Re: Reevaluation of Louisville and Southern Indiana Ohio River Bridges Project  
Floodplain Considerations

## Louisville-Southern Indiana Ohio River Bridges Floodplains Reevaluation

Supplemental Final Environmental Impact Statement (FHWA-KY-SEIS-12-01-F) approved  
April 20, 2012

This reevaluation was prepared to document and correct inconsistent statements about floodplains that appear in the Supplemental Final Environmental Impact Statement (SFEIS) and Revised Record of Decision (RROD) for the Louisville-Southern Indiana Ohio River Bridges Project. The reevaluation clarifies the Project commitment to bridge floodplains, where feasible, consistent with the recommendations of the US Environmental Protection Agency (EPA).

## **Bridging the 100-year floodplain of Lentzier Creek The Louisville – Southern Indiana Ohio River Bridges Project July 20, 2012**

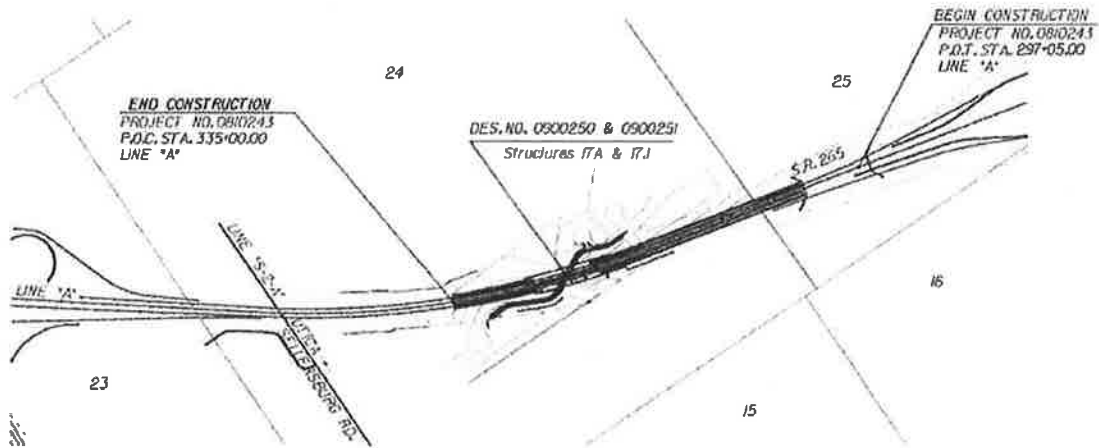
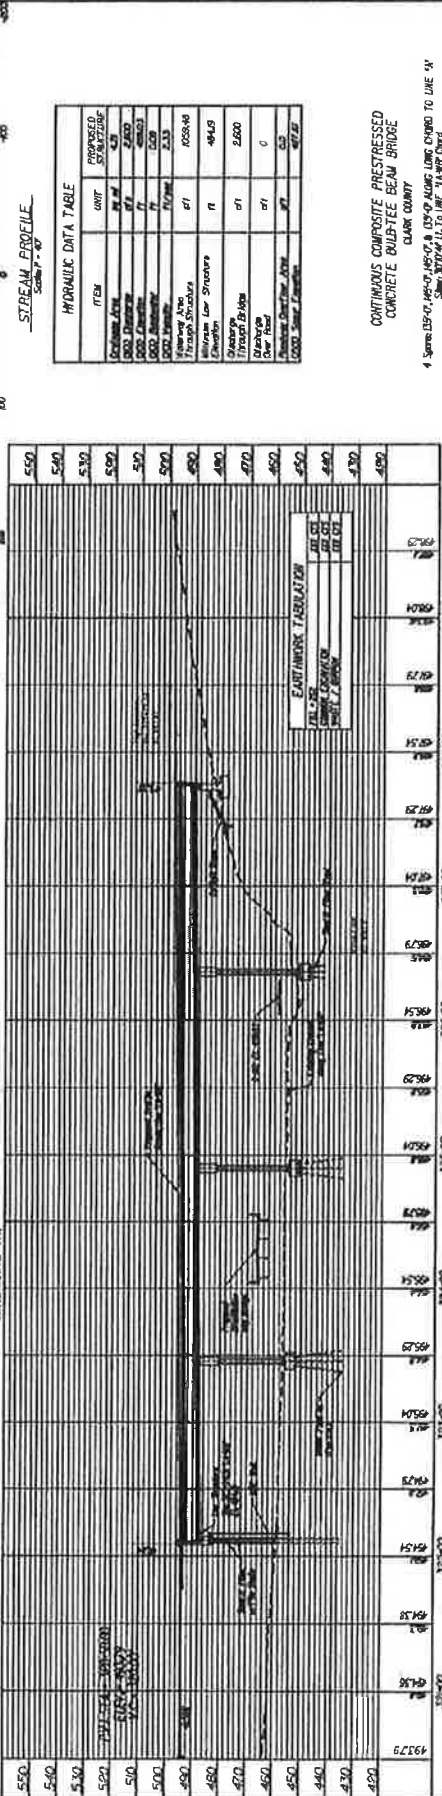
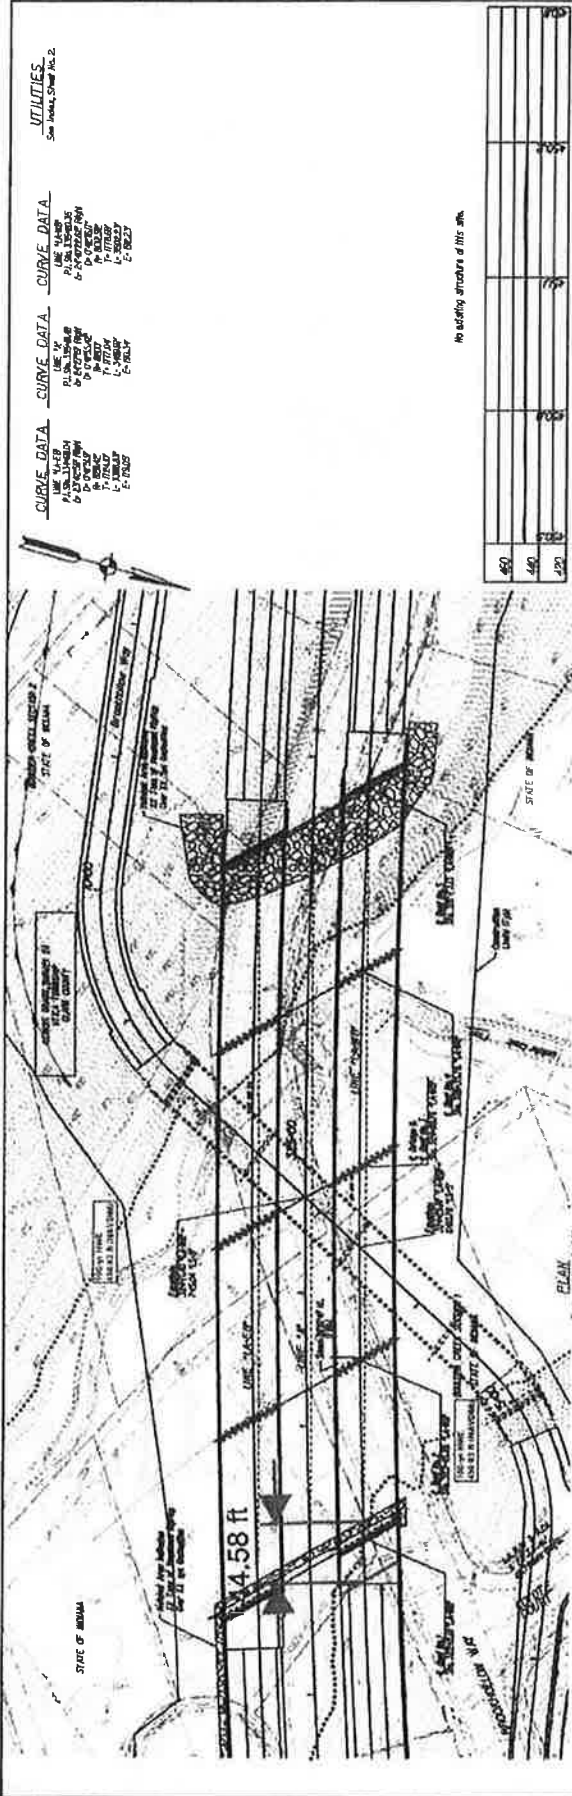
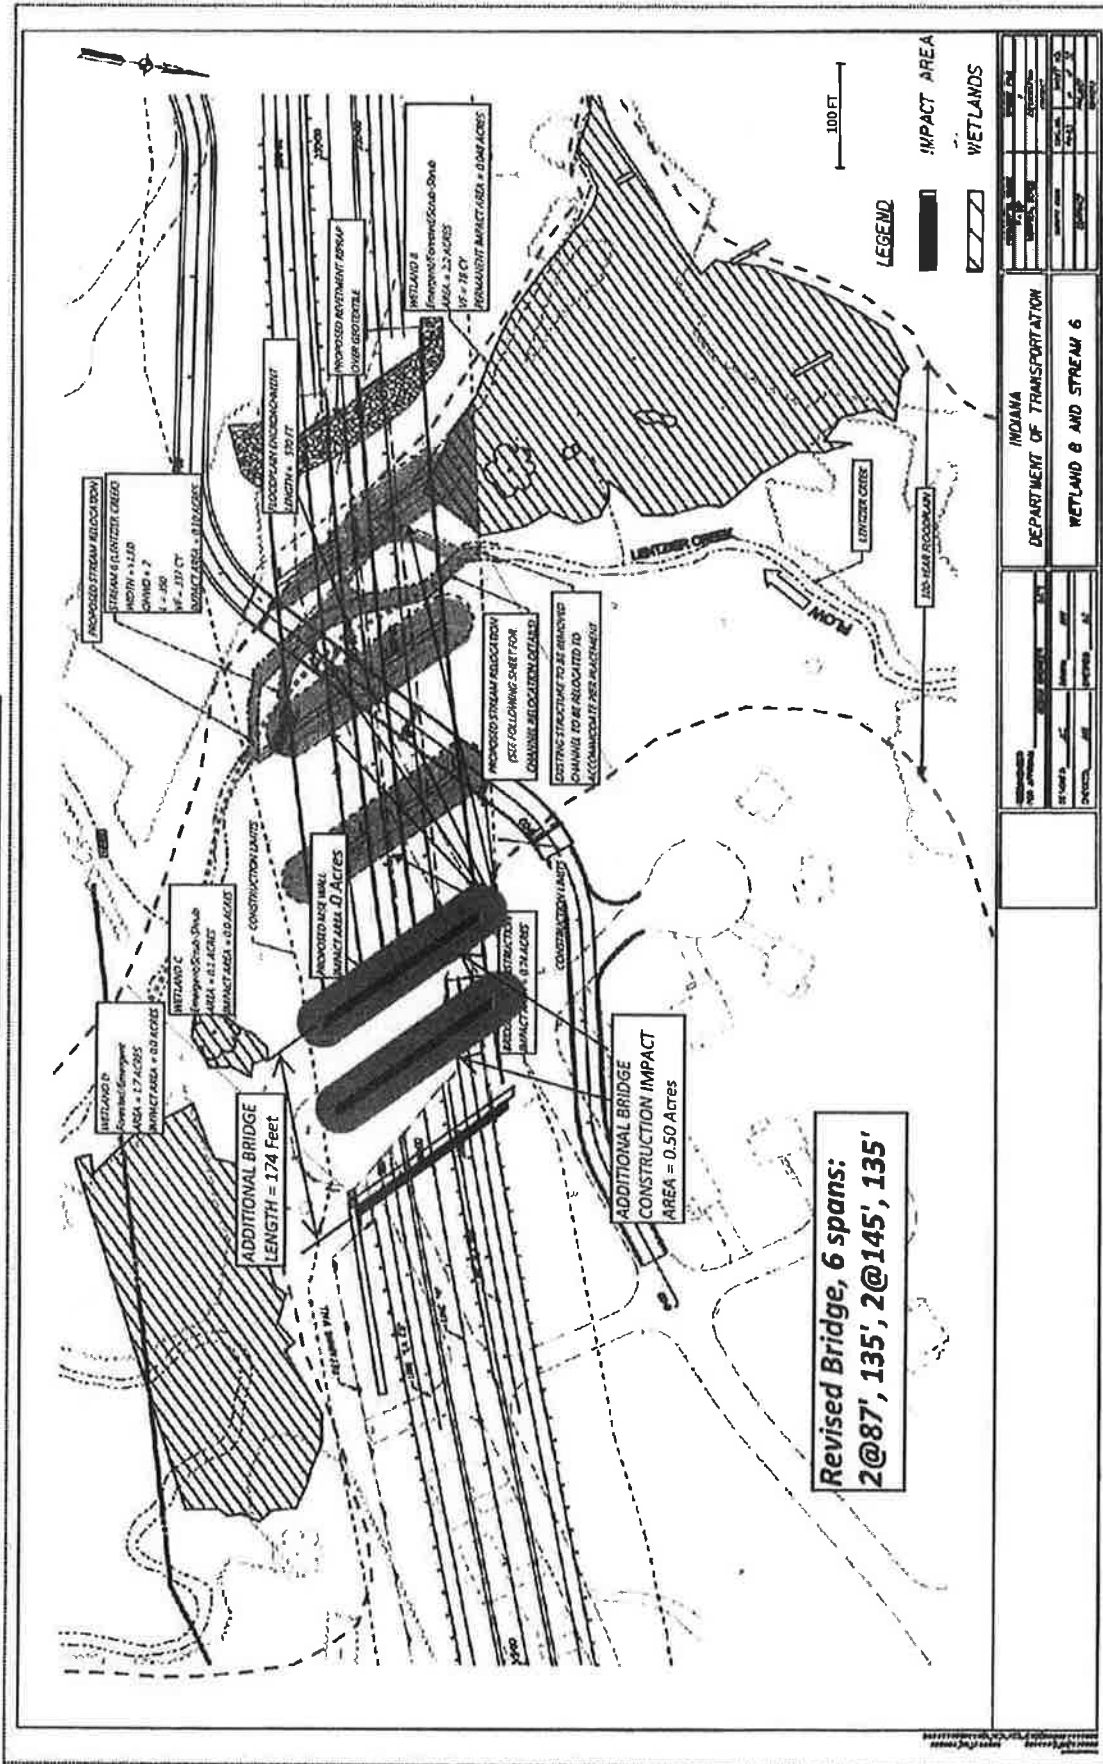
To span the entire floodplain, the I-265 structures will have to be lengthened 174' to the east. This will require two more spans @87'. Additionally, two more piers will have to be built in the floodplain.

Current Structures	Lengthened Structures
MSE Wall impact area	0.46 Ac	0
Pier Construction	0.74 Ac	1.24 Ac
Total	1.20 Ac	1.24 Ac
Flow Area	1018 sq .ft.	1038 sq .ft.
Backwater	0.05'	0.01'
Cost	\$5.0M	\$6.6M
Additional Cost	0	\$1.6M

As can be seen, the disturbance to the area of floodplain remains the same for either bridge length. The additional flow area at the upper elevations of floodplain provide a negligible benefit.

**Revised Bridge, 6 spans:  
2@87', 135', 2@145', 135'**
